Subject: Meeting Record: Fisheries and Oceans Canada – Parks Canada Agency – Canadian Zinc Corporation, March 7, 2017

MEETING RECORD

-Jess introduced the call: thanks everyone, the purpose of this call is to ask more questions regarding the hydrology of Sundog Creek specifically for the realignment. Previous discussions took place during a February 17th meeting and Bill reviewed the meeting minutes and had some very informative comments.

Fig. 1 (left): Correct example, Fig. 2 (right): Incorrect example. See email exchange below.

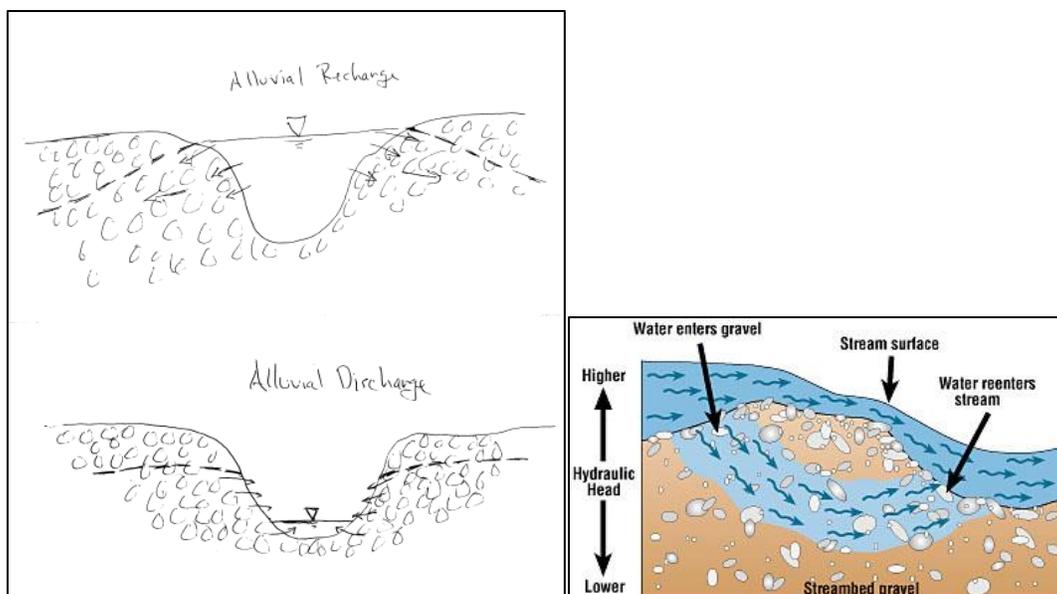
-referring to sketch: this is not separate groundwater system, it is more just water ponds into gravel adjacent to the stream

-Dave: yes, that's what Bill's illustrating in his top picture

I have attached a sketch (pdf document) to illustrate my interpretation of how the hyporheic zone exchanges along Sundog Ck are most likely to occur.

The jpg picture/cartoon diagram you provided does not portray what is going on. We can discuss further on Tuesday.

Image from Google

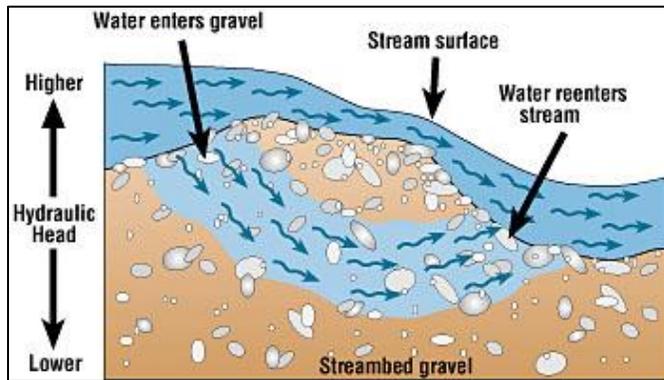
Thank you for agreeing to have a call with us on Tuesday regarding the hydrology of Sundog Creek. I took some time the other day to read more about the hyporheic zone and how it might work in Sundog Creek. I'm a visual learner, so does this attached picture/cartoon diagram portray an accurate example of the conditions in Sundog Creek?

The proposed berm will divert surface water, so subsurface water will daylight ("re-enter stream" as in the attached diagram) in certain locations downstream, and the amount of water will change depending on seasonal variation in flow(?). For Tuesday's call, I'm hoping to gain a better understanding of the hyporheic/subsurface flow in the existing main channel, what the interactions are like in the secondary/overflow channel (to be excavated), and anticipated conditions for post-realignment.
